## **APPENDIX 2**

### Correspondence Regarding Existing Humber River Hydrology and Flood Mapping (TRCA)

**From:** Mahdi Esmaili <Mahdi.Esmaili@trca.ca>  
**Sent:** August 21, 2020 4:37 PM  
**To:** Paul Chiocchio  
**Cc:** Dilnesaw Chekol; Andrew Fata  
**Subject:** RE: Humber Watershed - Bolton

# Flood Plain Map Viewer

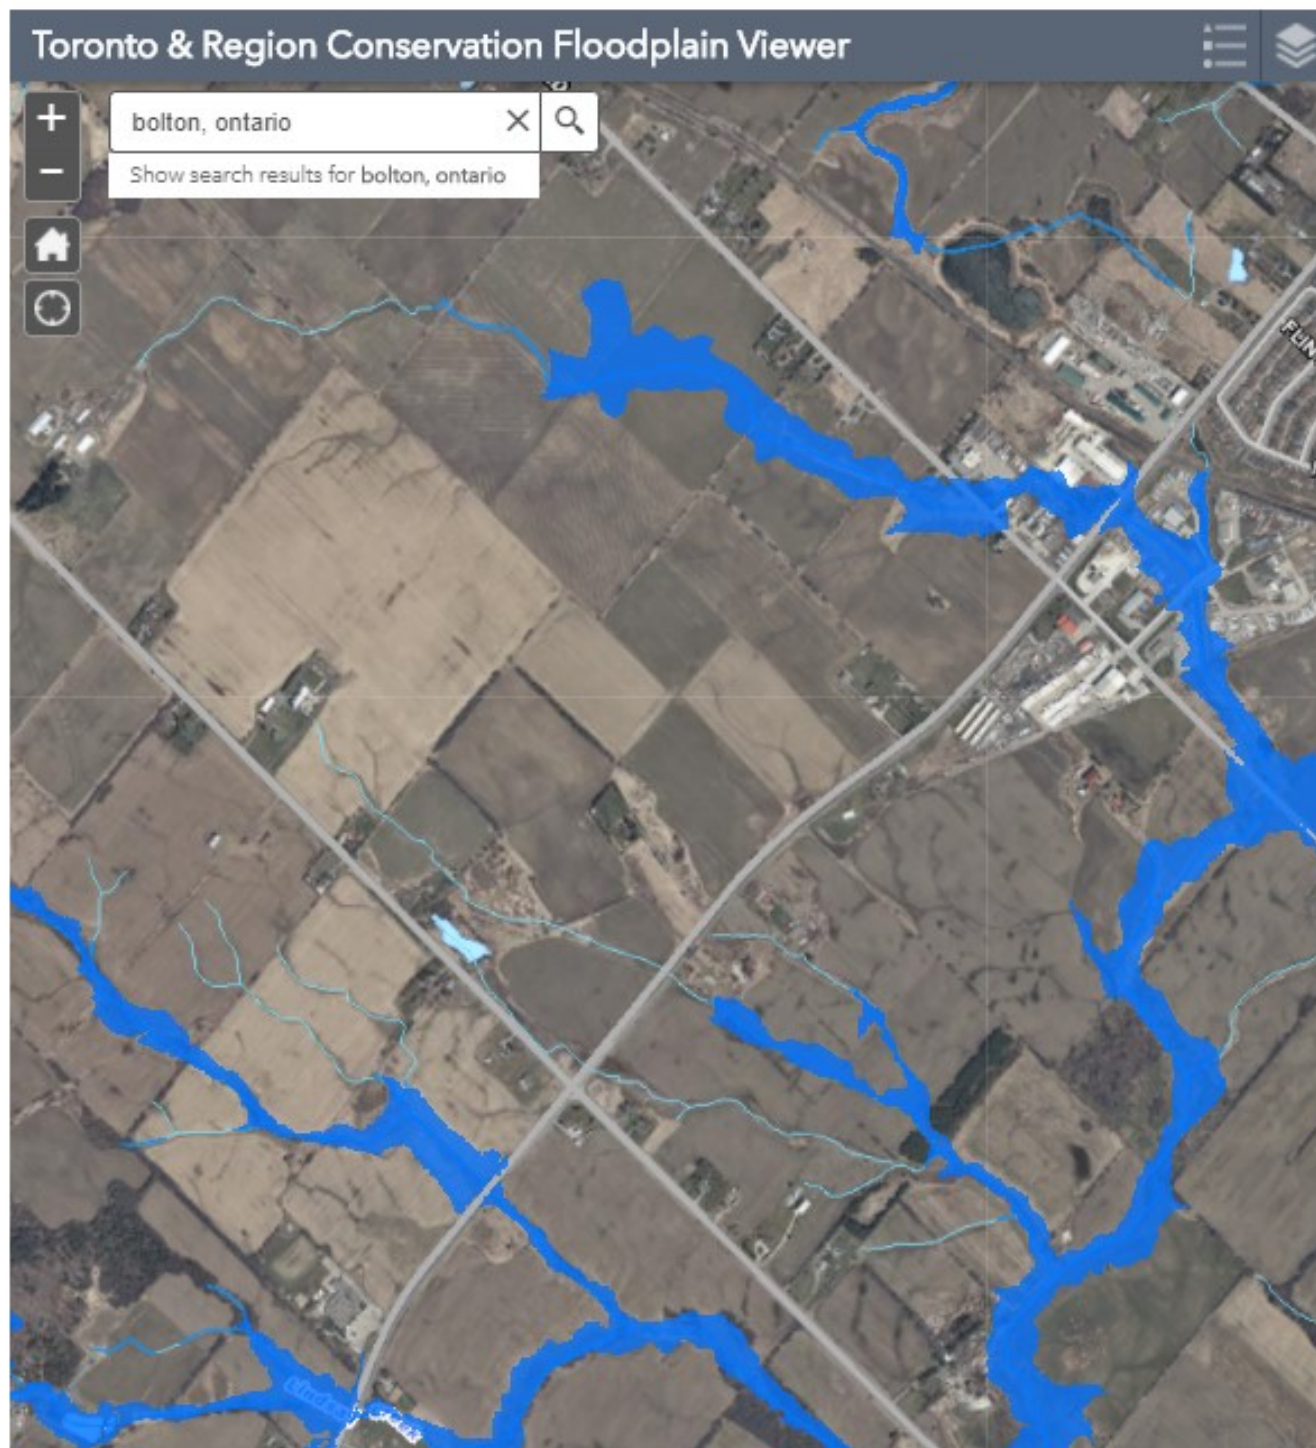
Just wondering if TRCA has HEC-RAS modelling that supports the flood mapping shown in the BRES 3 and 4 lands in Bolton (see below).

If so, can we make a formal data request to get these models?

The TRCA hydraulic modeling for this area is "Estimated".

The Estimated floodplain modelling and mapping was intended to be used as a screening tool for development applications submitted to the TRCA, to determine whether existing or proposed sites, properties or structures are potentially susceptible to flooding. This information is the best available at this time but is not appropriate for many uses since the model doesn't include crossing structures, doesn't have refined Manning's n values, and the crossing geometry is not detailed. Thus, TRCA water resources engineering staff recommend that the proponent use TRCA's available modelling and mapping to conduct the hydraulic analysis for their project, refine the model and create an engineered HEC-RAS model.

If you are interested in obtaining the estimated model, please let me know and I will send you the TRCA Data Sharing Agreement and the invoice. The fee for the model is 100\$+HST.

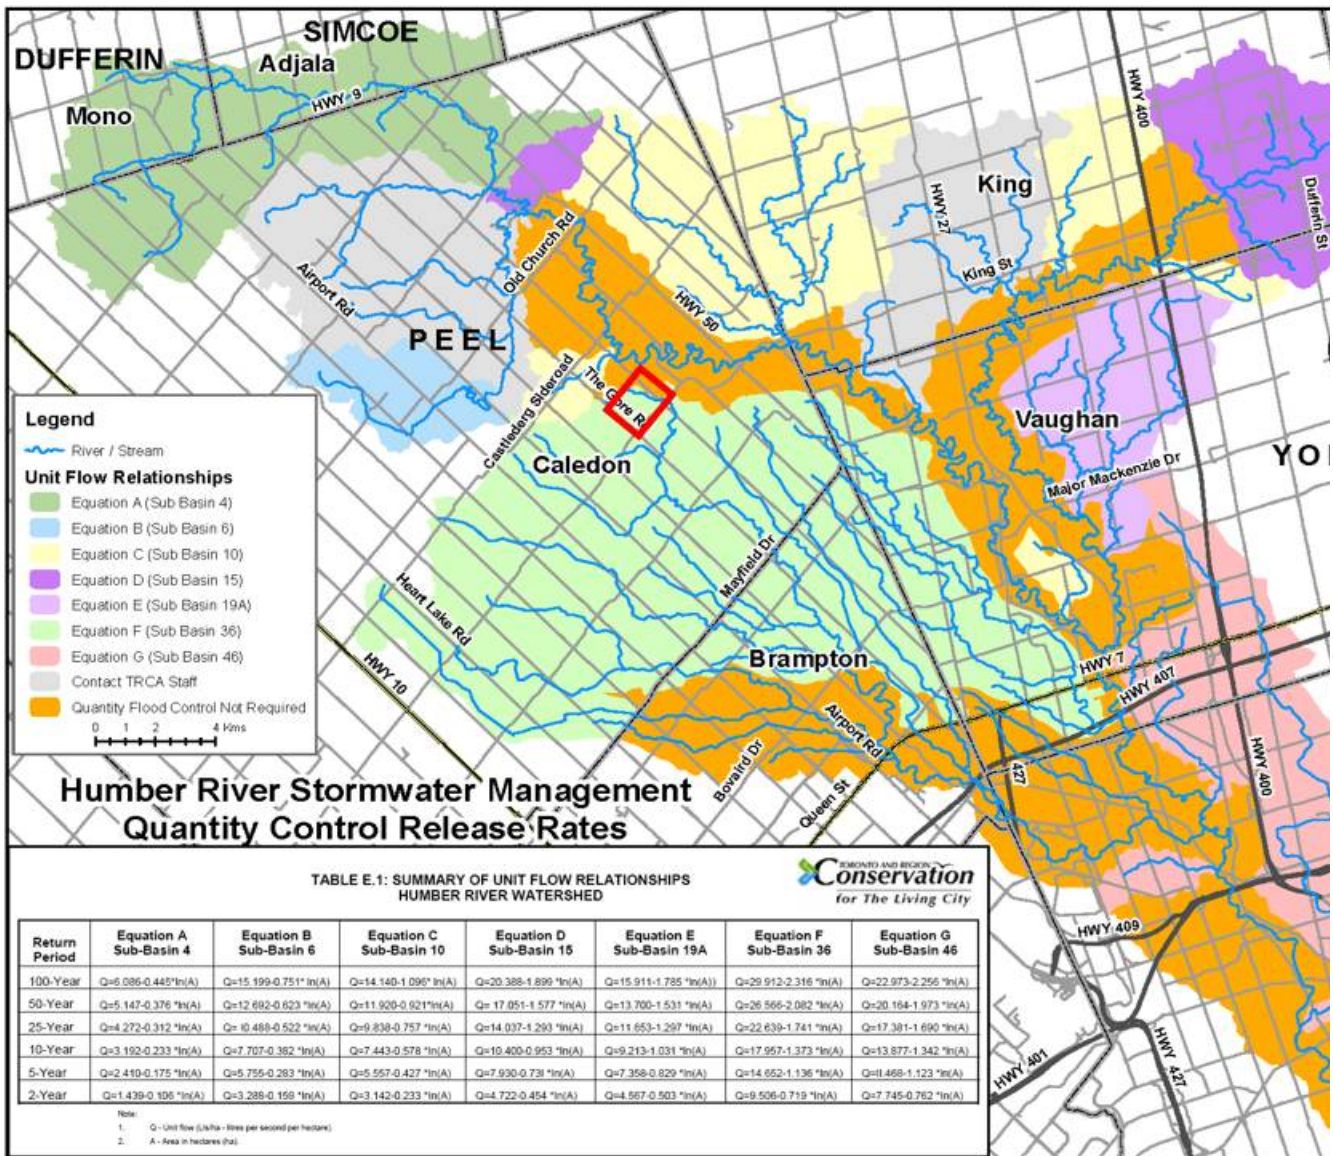
Here are SWM criteria for the site.

1. Quantity control:

As it is shown in the map below, the northeast section of the property (the orange section), quantity control is not required, however quantity control is required for the remaining section of the site. The quantity control for this site is as follows post-development peak flows should be controlled pre-development peak flows and pre-development target flows for quantity control should be based on unit flow rates of Equation F (see the map below) and existing drainage draining in to the receiving features for the 2-100 year.

It appears that as this site was not included in the approved OP when the Humber River Hydrology was updated in 2015, Regional control is required as per Humber River Watershed Plan.

2. Quality Control.  
Enhanced level treatment is required for the site.
3. Site Water Balance  
On-site retention of 5mm runoff from total impervious area.

4. Erosion Control.  
If the site discharges to the main Humber River, then the generic erosion criteria of retaining runoff generated from 25mm of rain for 48 hrs. However, if the site is discharging to any headwater features or an ephemeral watercourse, then TRCA requires a full-fledged erosion assessment should be conducted as per the methodology referenced in Section 4 and Appendix B of TRCA's SWM Criteria Document in order to avoid stream erosion on these features.
